Errata

This errata sheet is for MB90385 Series Hardware Manual Rev.5 (CM44-10118-5E)

F²MC-16LX
 16-BIT MICROCONTROLLER
 MB90385 Series
 HARDWARE MANUAL

Addendum, MB90385 Hardware Manual (CM44-10118-5E)

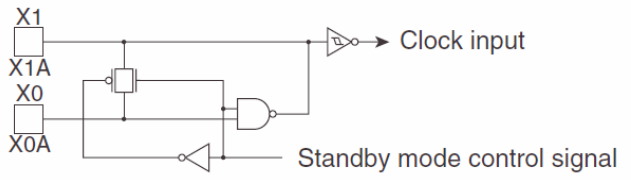
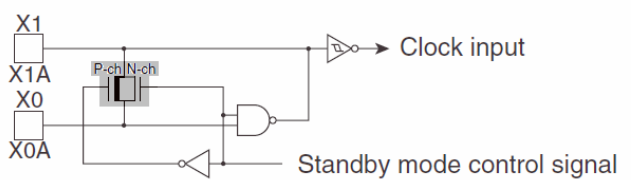
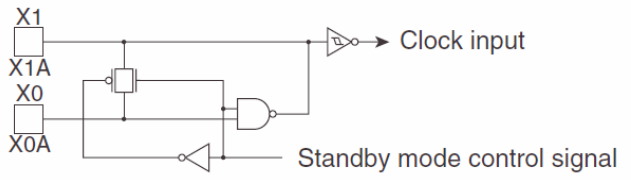
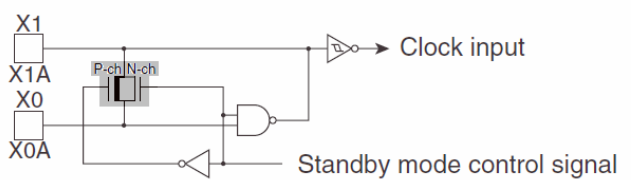
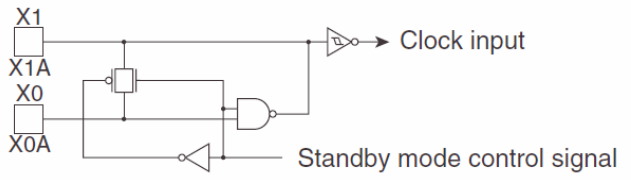
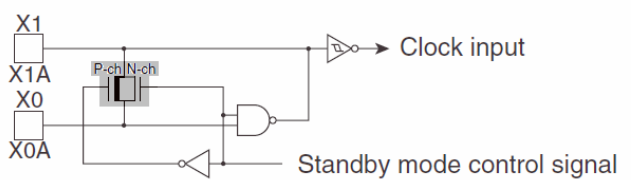
Date	Page	Item	Description								
2008/8/8	-	-	See the following page for details.								
2009/4/2	14	1.7	<p>The following description of "Classification A" in "Table 1.7-1 I/O Circuit" was corrected as indicated by shading below.</p> <p>(Error)</p> <table border="1" data-bbox="487 745 1372 1008"> <thead> <tr> <th data-bbox="487 745 641 770">Classification</th> <th data-bbox="641 745 1372 770">Circuit</th> </tr> </thead> <tbody> <tr> <td data-bbox="487 770 641 1008">A</td> <td data-bbox="641 770 1372 1008">  </td> </tr> </tbody> </table> <p>(Correct)</p> <table border="1" data-bbox="487 1060 1372 1323"> <thead> <tr> <th data-bbox="487 1060 641 1085">Classification</th> <th data-bbox="641 1060 1372 1085">Circuit</th> </tr> </thead> <tbody> <tr> <td data-bbox="487 1085 641 1323">A</td> <td data-bbox="641 1085 1372 1323">  </td> </tr> </tbody> </table> <p style="text-align: right;">[mcu_doc0872]</p>	Classification	Circuit	A		Classification	Circuit	A

Date	Page	Item	Description																																																		
2009/4/2	161	4.3	<p>"Table 4.3-1 Pin Assignment of Port 1" was corrected as indicated by the shading below.</p> <p>(Error)</p> <table border="1"> <thead> <tr> <th rowspan="2">Port Name</th> <th rowspan="2">Pin Name</th> <th rowspan="2">Port Function</th> <th colspan="2" rowspan="2">Resource</th> <th colspan="2">I/O Type</th> <th rowspan="2">Circuit Type</th> </tr> <tr> <th>Input</th> <th>Output</th> </tr> </thead> <tbody> <tr> <td rowspan="4">Port 1</td> <td>P10/IN0</td> <td>P10</td> <td rowspan="4">General purpose I/O port</td> <td rowspan="4">IN0</td> <td rowspan="4">Input capture input</td> <td rowspan="4">CMOS (hysteresis)</td> <td rowspan="4">CMOS</td> <td rowspan="4">D</td> </tr> <tr> <td>P11/IN1</td> <td>P11</td> </tr> <tr> <td>P12/IN2</td> <td>P12</td> </tr> <tr> <td>P13/IN3</td> <td>P13</td> </tr> </tbody> </table> <p>(Correct)</p> <table border="1"> <thead> <tr> <th rowspan="2">Port Name</th> <th rowspan="2">Pin Name</th> <th rowspan="2">Port Function</th> <th colspan="2" rowspan="2">Resource</th> <th colspan="2">I/O Type</th> <th rowspan="2">Circuit Type</th> </tr> <tr> <th>Input</th> <th>Output</th> </tr> </thead> <tbody> <tr> <td rowspan="4">Port 1</td> <td>P10/IN0</td> <td>P10</td> <td rowspan="4">General purpose I/O port</td> <td rowspan="4">TIN0</td> <td rowspan="4">Input capture input</td> <td rowspan="4">CMOS (hysteresis)</td> <td rowspan="4">CMOS</td> <td rowspan="4">D</td> </tr> <tr> <td>P11/IN1</td> <td>P11</td> </tr> <tr> <td>P12/IN2</td> <td>P12</td> </tr> <tr> <td>P13/IN3</td> <td>P13</td> </tr> </tbody> </table> <p style="text-align: right;">[mcu_doc0800]</p>	Port Name	Pin Name	Port Function	Resource		I/O Type		Circuit Type	Input	Output	Port 1	P10/IN0	P10	General purpose I/O port	IN0	Input capture input	CMOS (hysteresis)	CMOS	D	P11/IN1	P11	P12/IN2	P12	P13/IN3	P13	Port Name	Pin Name	Port Function	Resource		I/O Type		Circuit Type	Input	Output	Port 1	P10/IN0	P10	General purpose I/O port	TIN0	Input capture input	CMOS (hysteresis)	CMOS	D	P11/IN1	P11	P12/IN2	P12	P13/IN3	P13

Date	Page	Item	Description																																				
2009/4/2	226	7.3.1	<p>"Table 7.3-2 Functions of Timer Counter Control Status Register (TCCS)" was corrected as indicated by the shading below.</p> <p>(Error)</p> <table border="1"> <thead> <tr> <th>Bit Name</th> <th>Function</th> </tr> </thead> <tbody> <tr> <td>bit 7 IVF: Overflow generation flag bit</td> <td>This bit indicates that the 16-bit free-run timer has overflowed. • If the 16-bit free-run timer overflows or mode setting causes a compare match with the compare register 0 to clear the counter, this bit is set to "1".</td> </tr> <tr> <td>---</td> <td>---</td> </tr> </tbody> </table> <p>(Correct)</p> <table border="1"> <thead> <tr> <th>Bit Name</th> <th>Function</th> </tr> </thead> <tbody> <tr> <td>bit 7 IVF: Overflow generation flag bit</td> <td>This bit indicates that the 16-bit free-run timer has overflowed. • If the 16-bit free-run timer overflows, this bit is set to "1".</td> </tr> <tr> <td>---</td> <td>---</td> </tr> </tbody> </table> <p style="text-align: right;">[mcu_doc0800]</p>	Bit Name	Function	bit 7 IVF: Overflow generation flag bit	This bit indicates that the 16-bit free-run timer has overflowed. • If the 16-bit free-run timer overflows or mode setting causes a compare match with the compare register 0 to clear the counter, this bit is set to "1".	---	---	Bit Name	Function	bit 7 IVF: Overflow generation flag bit	This bit indicates that the 16-bit free-run timer has overflowed. • If the 16-bit free-run timer overflows, this bit is set to "1".	---	---

Date	Page	Item	Description												
2009/4/2	449	15.3.8	<p>"Table 15.3-10 Functions of Transmission Request Register (TREQR)" was corrected as indicated by the shading below.</p> <p>(Error)</p> <table border="1"> <thead> <tr> <th colspan="2">Bit name</th> <th>Function</th> </tr> </thead> <tbody> <tr> <td>bit 7 to bit 0</td> <td>TREQ7 to TREQ0: Transmission request bits 7 to 0</td> <td>--- Read by read modify write (RMW) instruction: "1" is always read. [Setting of remote frame receive wait bit (RFWTR: RFWTx)] ---</td> </tr> </tbody> </table> <p>(Correct)</p> <table border="1"> <thead> <tr> <th colspan="2">Bit name</th> <th>Function</th> </tr> </thead> <tbody> <tr> <td>bit 7 to bit 0</td> <td>TREQ7 to TREQ0: Transmission request bits 7 to 0</td> <td>--- Read by read modify write (RMW) instruction: "0" is always read. [Setting of remote frame receive wait bit (RFWTR: RFWTx)] ---</td> </tr> </tbody> </table> <p style="text-align: right;">[mcu_doc0689]</p>	Bit name		Function	bit 7 to bit 0	TREQ7 to TREQ0: Transmission request bits 7 to 0	--- Read by read modify write (RMW) instruction: "1" is always read. [Setting of remote frame receive wait bit (RFWTR: RFWTx)] ---	Bit name		Function	bit 7 to bit 0	TREQ7 to TREQ0: Transmission request bits 7 to 0	--- Read by read modify write (RMW) instruction: "0" is always read. [Setting of remote frame receive wait bit (RFWTR: RFWTx)] ---

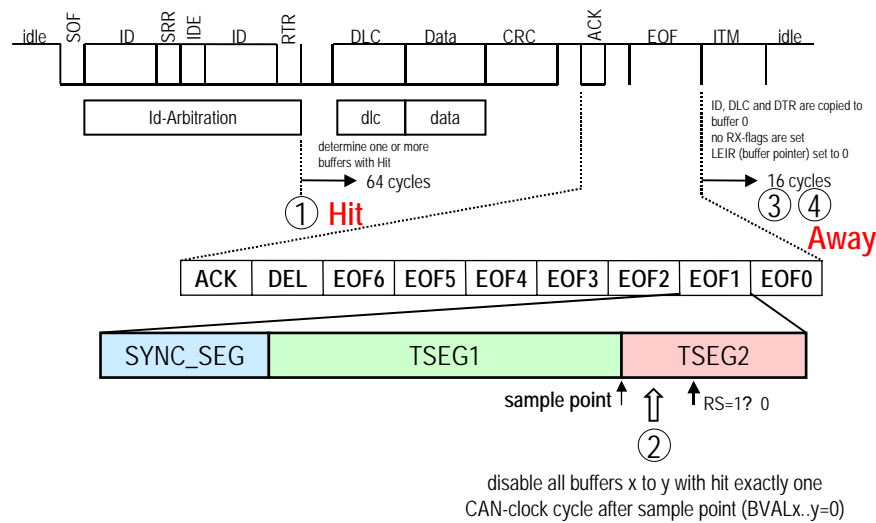
When disabling message buffers by the BVAL register, it must be avoided that the write operation to the BVAL register coincides with the store operation of the received message in the CAN Controller.

The following diagram illustrates the timing to be avoided for the BVAL write operation.

- ① CAN-controller determines buffers, which can store the message, because their acceptance filters had been passed.
- ② Software disable all buffers with hit exactly one CAN-clock cycle after the sample point of EOF1.
- ③ CAN-controller stores received ID, DLC and data in buffer 0 regardless of the buffers determined in ①.
- ④ CAN-Controller sets LEIR to point to buffer 0 but RX-flags (RCR, ROVR, RRTRR) are not set.

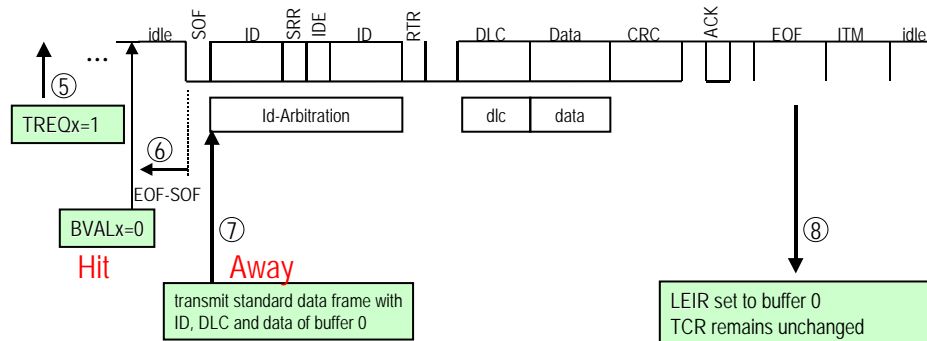
When disabling message buffers by the BVAL register, it must be avoided that the write operation to the BVAL register coincides with the preparation for the next transmission in the CAN Controller. The following diagram illustrates the timing to be avoided for the BVAL write operation.

- ⑤ Software requests transmission of buffer x by setting TREQx.
- ⑥ Software disables the buffer x by clearing BVALx.
- ⑦ CAN-controller transmits a standard data frame with ID, length code and data of buffer 0.
- ⑧ After completion of frame only LEIR is updated for buffer 0. However, TCR is not set (neither for buffer 0 nor for buffer x).
